SUBJECT: REVIEW OF INTERIM REMEDIAL ACTION PLAN FOR EAST ADJACENT PROPERTIES, PURSUANT TO CALIFORNIA WATER CODE SECTION 13304 CLEANUP AND ABATEMENT ORDER NO. R4-2021-0079

SITE: SKYPARK COMMERCIAL PROPERTIES (ASSESSOR PARCEL NO. 7377-006-906), 24701 – 24777 CRENSHAW BOULEVARD AND 2530, 2540, AND 2600 SKYPARK DRIVE, TORRANCE, CALIFORNIA (SCP NO. 1499)

On February 28, 2022, the Los Angeles Water Board staff received the *Removal Action Workplan for the East Adjacent Properties* (EAP IRAP), submitted on behalf of the City of Torrance by Terraphase Engineering Inc. (Terraphase) for review.

Attachment 3 - Figure 21 – Proposed Regional Groundwater Remediation Area

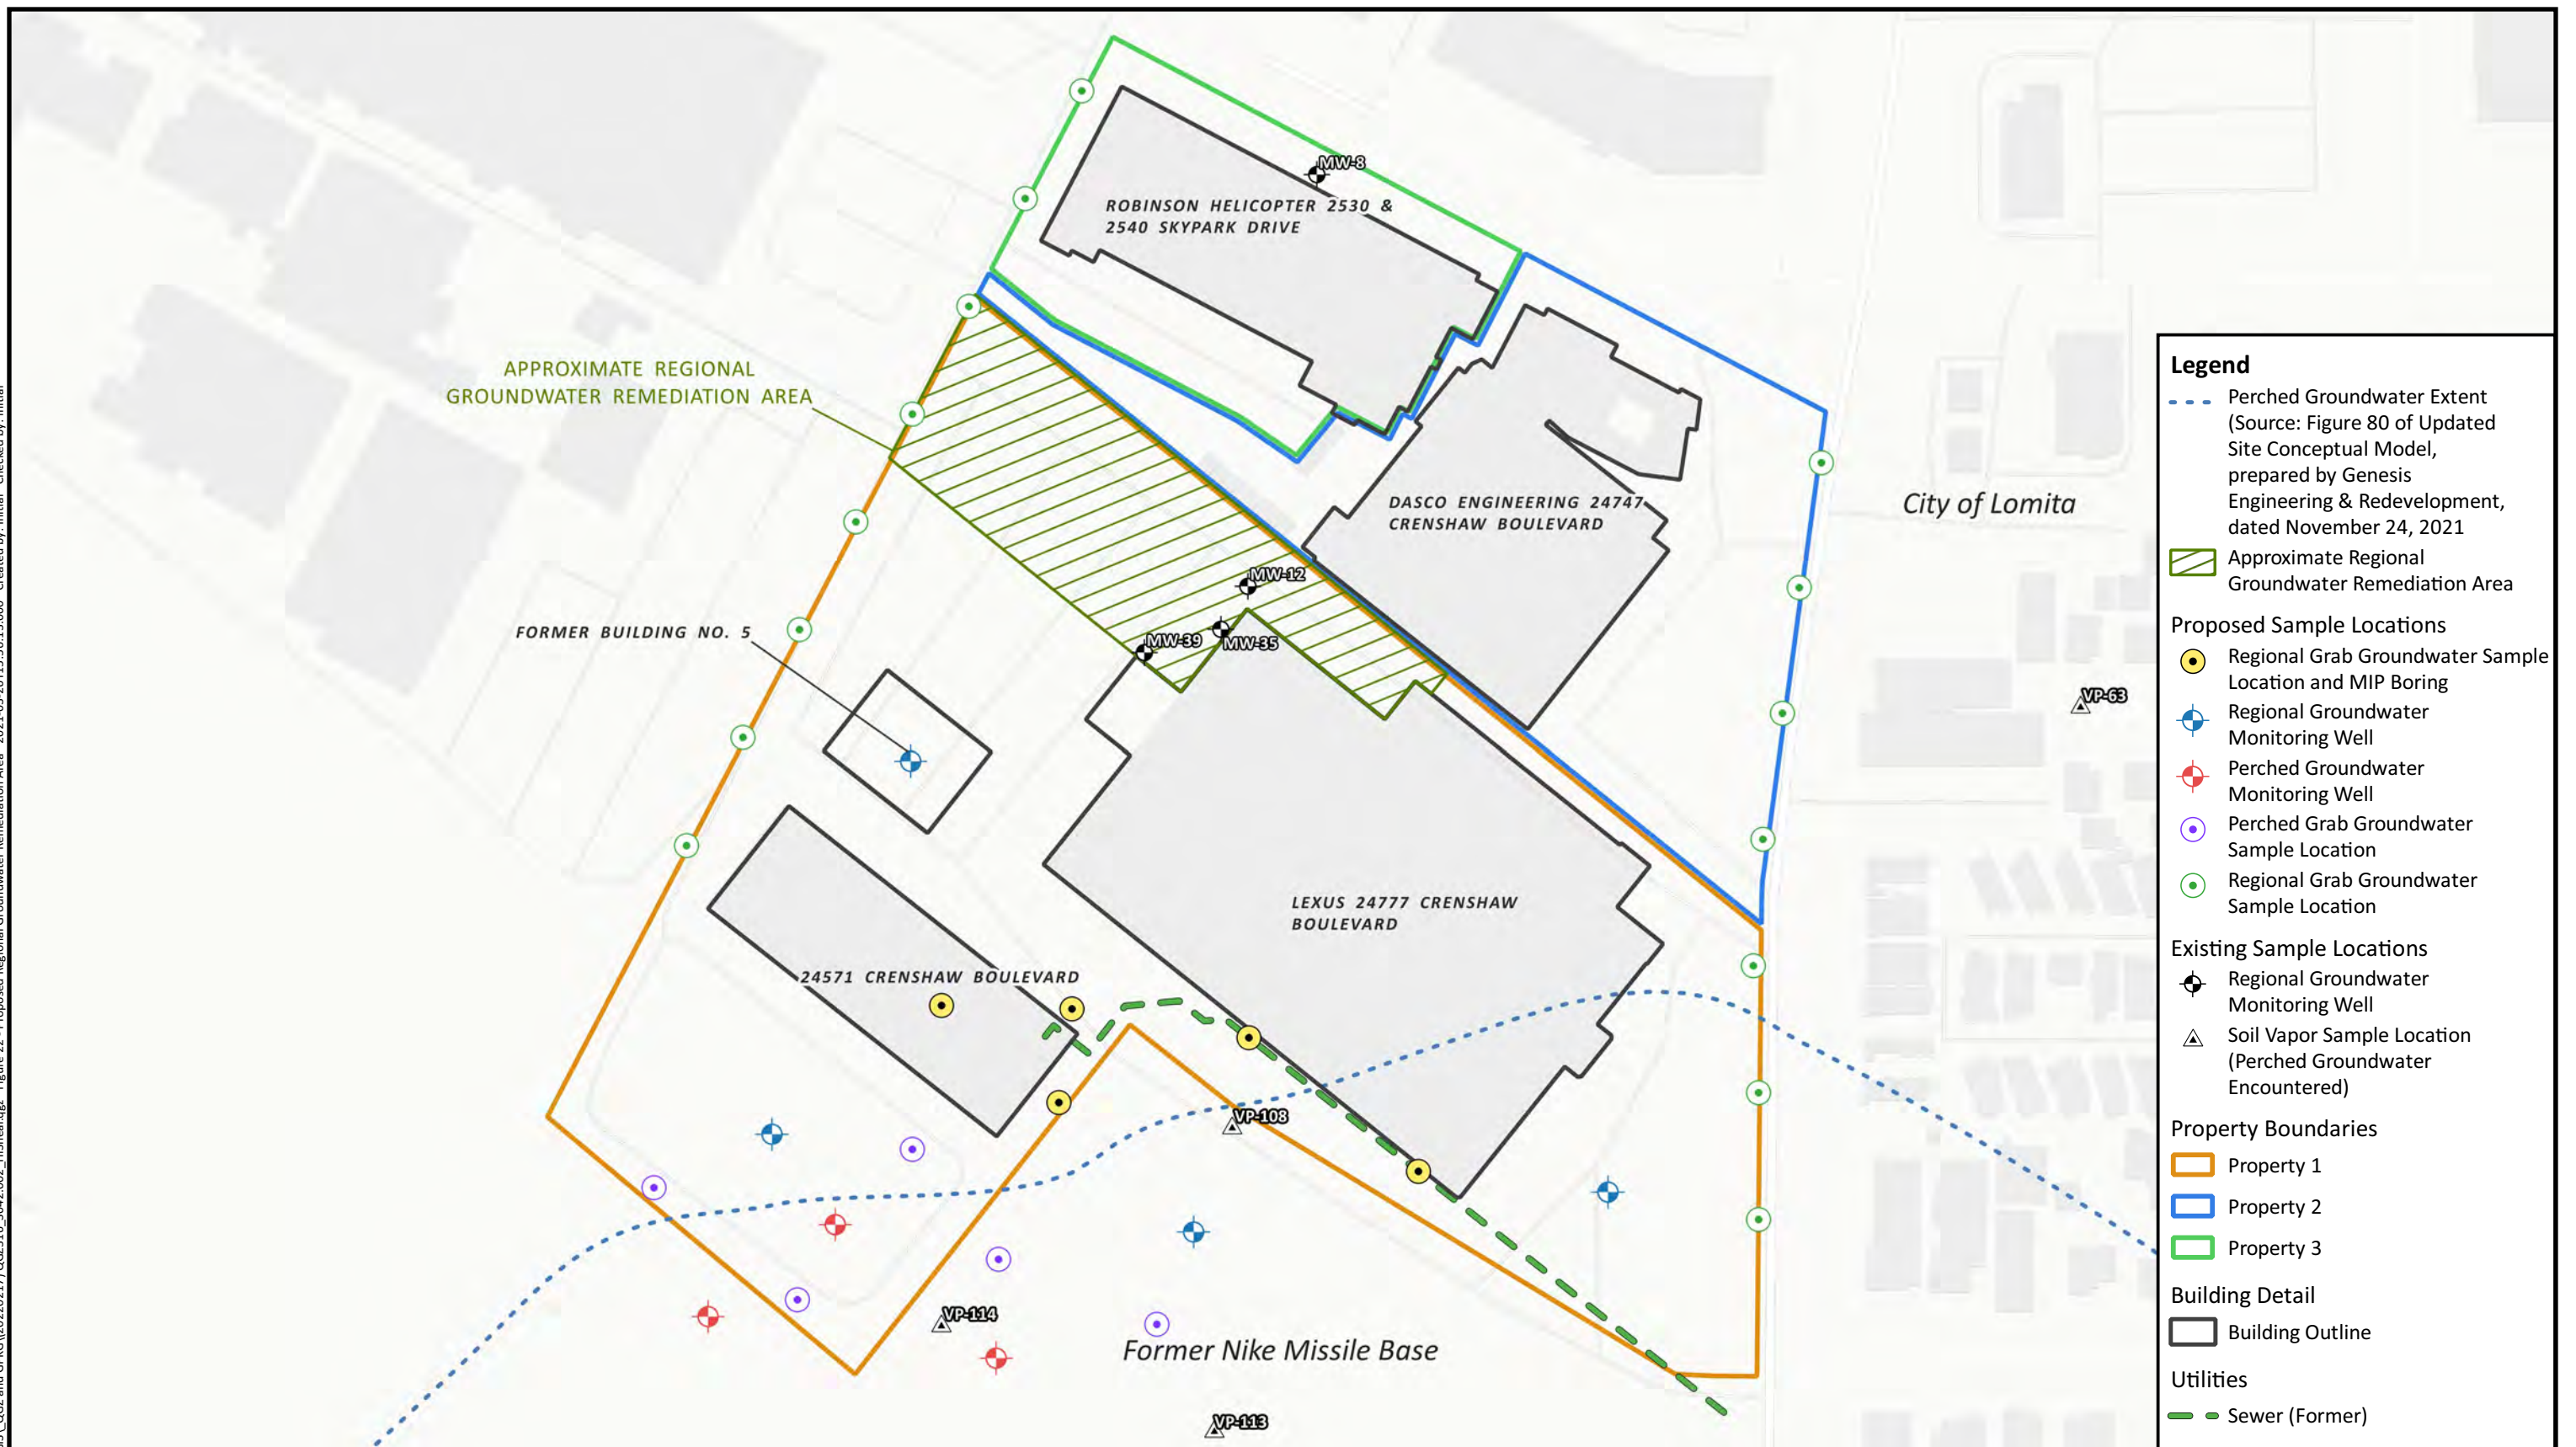
4. Data reported in the *Third Tri-Annual 2021 Groundwater Monitoring Report*, dated February 25, 2022, submitted on behalf of Hamrick & Evans, LLP (attorney representative for Hi-Shear Corporation) by Genesis Engineering & Redevelopment, Inc., indicate elevated concentrations of VOCs detected in well MW-8. Concentrations of tetrachloroethene (PCE), trichloroethene (TCE), and 1,1-dichloroethene (1,1-DCE) in groundwater at MW-8 were 527 µg/L, 16,600 µg/L, and 93.2 µg/L, respectively. These recent concentrations of PCE, TCE, and 1,1-DCE in groundwater at MW-8 are 15 times greater than their respective State Water Resources Control Board Division of Drinking Water's MCLs of 5 µg/L, 5 µg/L, and 6 µg/L, respectively, and have historically been elevated and have recently increased. Therefore, the selected remedial alternative for regional groundwater (i.e., EISB) should also include injection points in the vicinity of groundwater monitoring well MW-8.

5. The proposed injection locations for ISCO and EISB are not included in the Figure 21 and Figure 22 of the EAP IRAP. Provide figure(s) showing the proposed injection locations with additional details and justifications on the locations, depths of injections, and injectate volumes in the text of the EAP IRAP.

- c. *Table 2 – Data Gap Investigation Cost Estimate* show four regional groundwater monitoring wells are budgeted for installation and Figure 20 depicts four regional groundwater monitoring wells. However, the text of the EAP IRAP proposes the installation of five regional groundwater monitoring wells. The proposed groundwater monitoring well on Property 2 is not included in Figure 20 and Figure 21 of the EAP IRAP.

Attachment 4 - Figure 22 – Proposed Vadose Zone and Perched Groundwater Remediation Areas

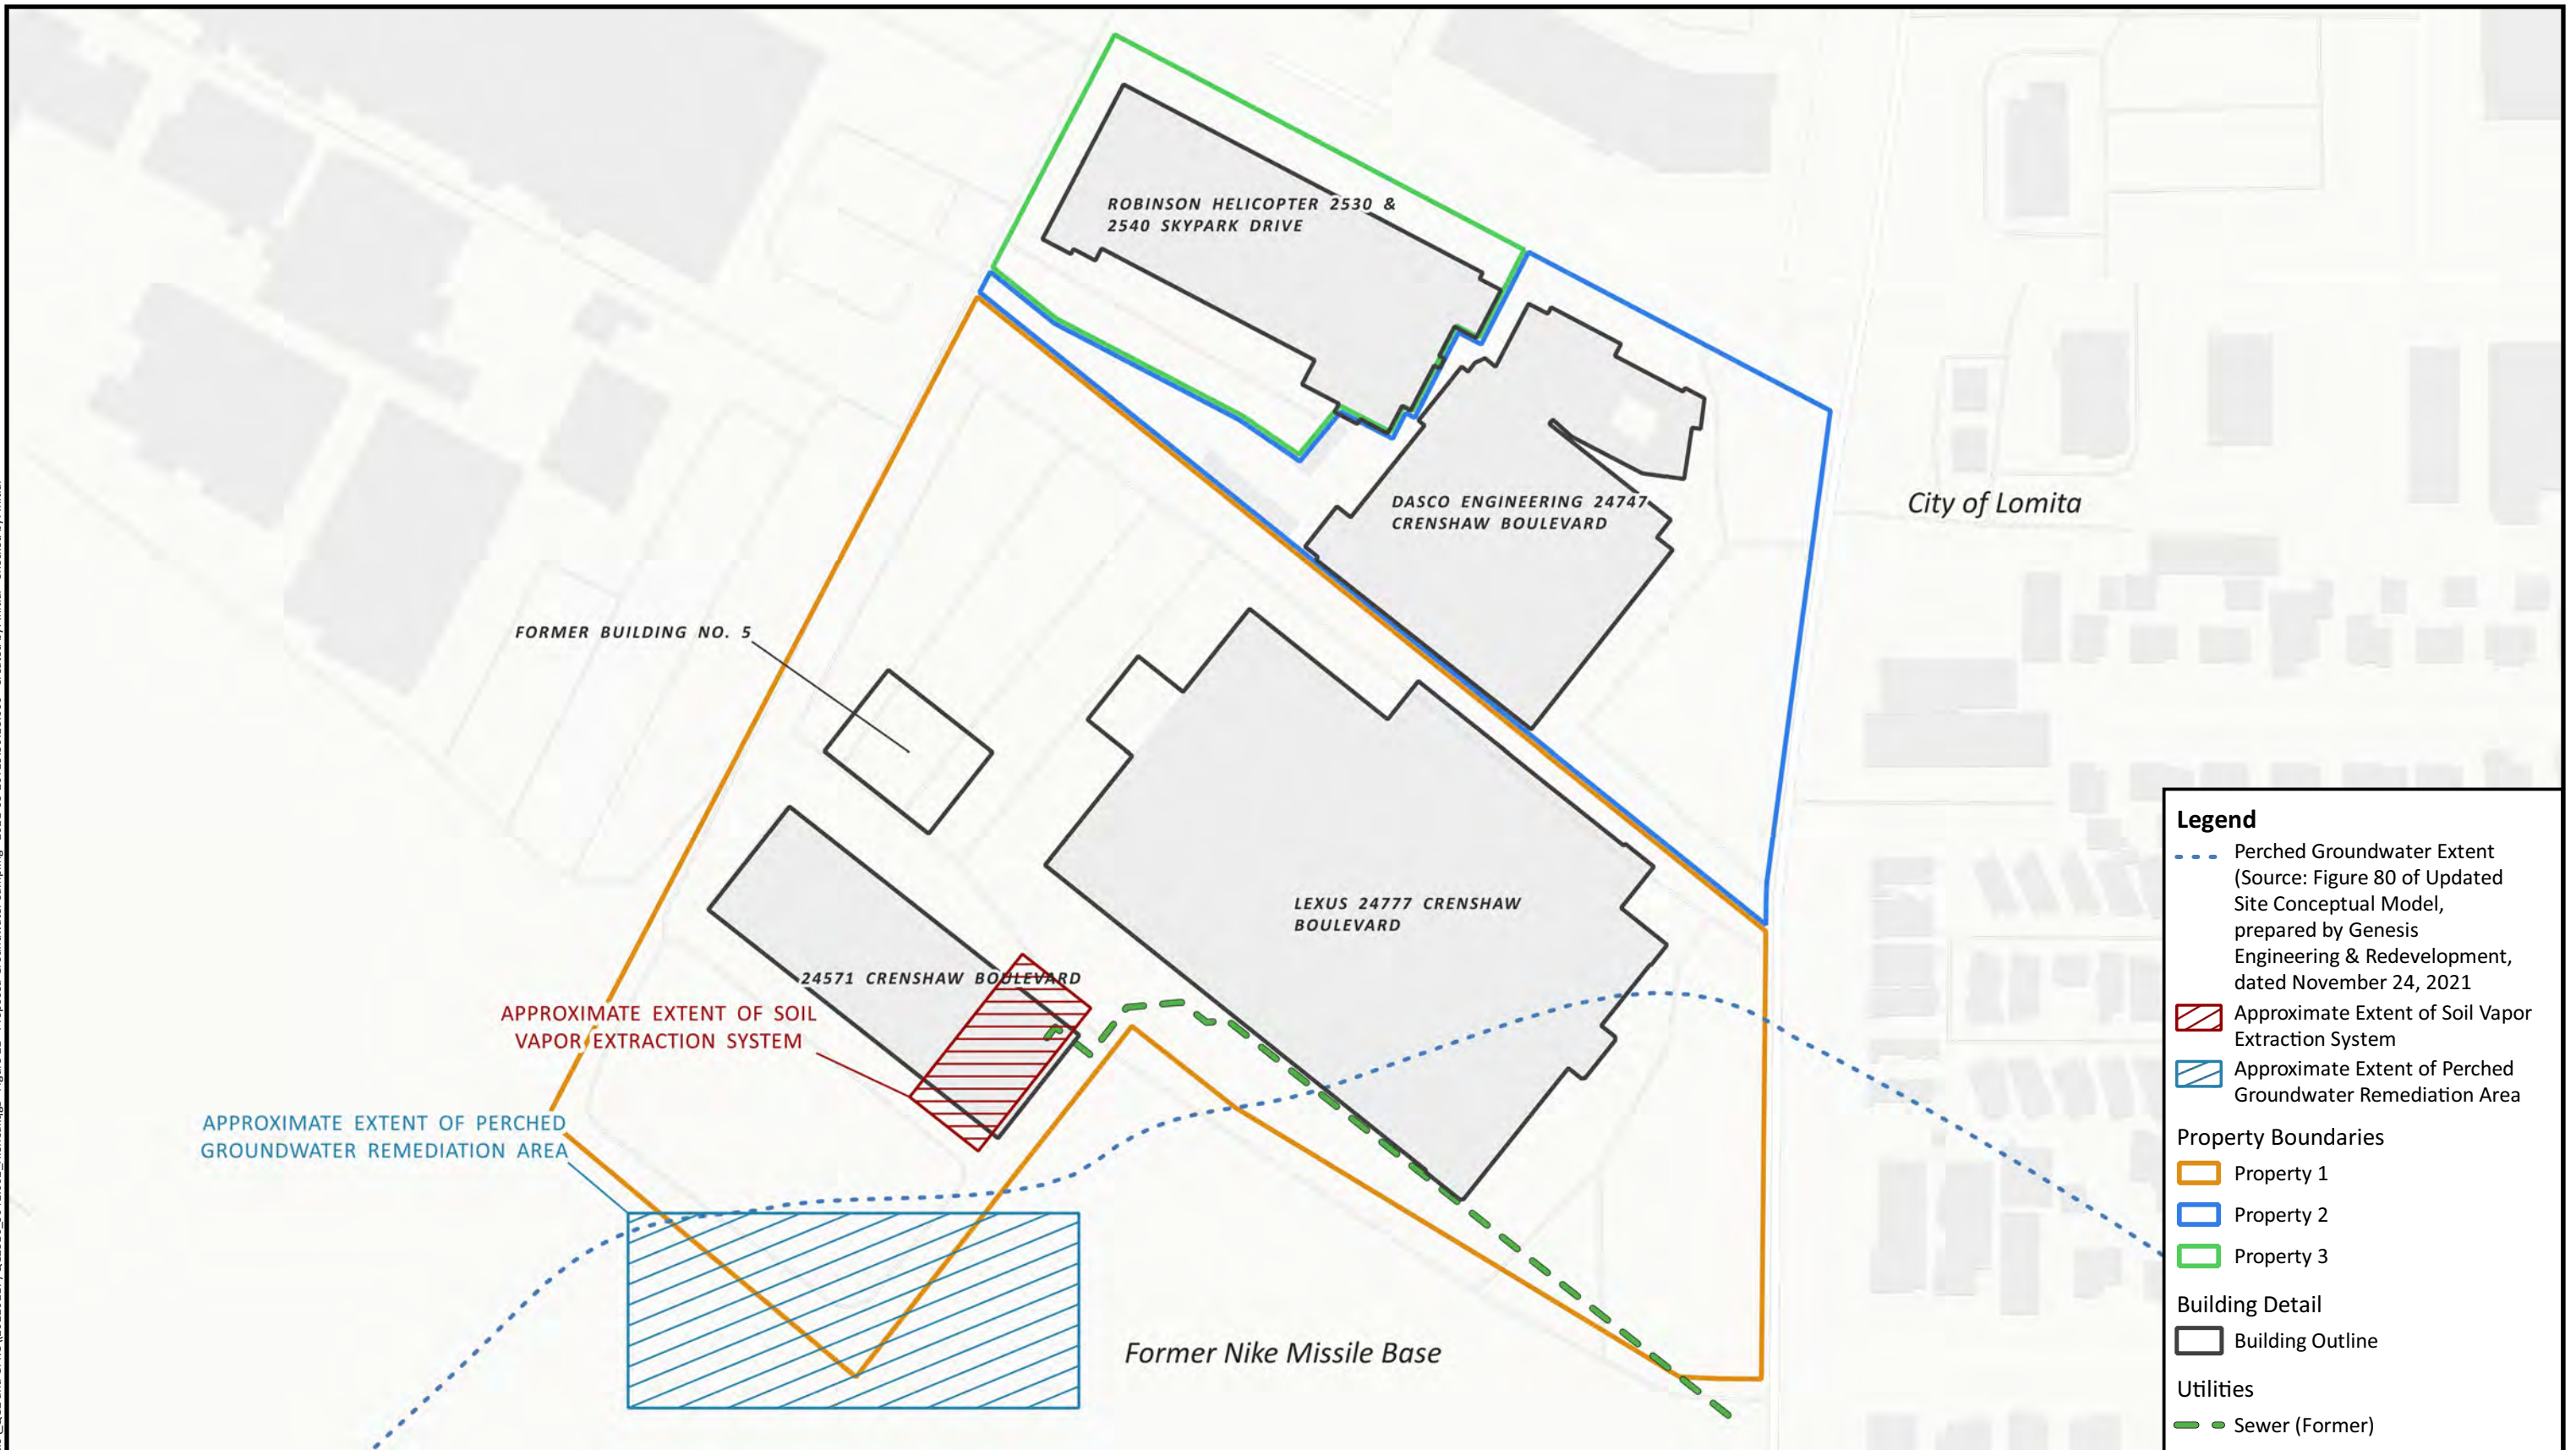
2. The proposed 24 SVE well locations are not shown on Figure 22. Provide a figure showing the proposed SVE well locations with additional details and justifications on the locations and the depths of the screened intervals.

- a. SVE wells should be located and screened to address the current known lateral and vertical extent of VOC contamination at the EA Properties. At a minimum, the SVE wells should address areas in the vicinity of soil vapor probe locations VP-25, VP-26, VP-31, VP-46, VP-47, VP-48, VP-49, VP-50, VP-107, VP-108, VP-113, VP-114, VP-132 and VP-133.

- b. The SVE well screened intervals should not be limited to the proposed screened intervals of 5 to 25 ft-bgs and 25 to 45 ft-bgs. Soil vapor data indicate impacts extend beyond 45 ft-bgs down to 85 ft-bgs. Additional SVE wells and/or screened intervals should be proposed to address the impacts at these depths.
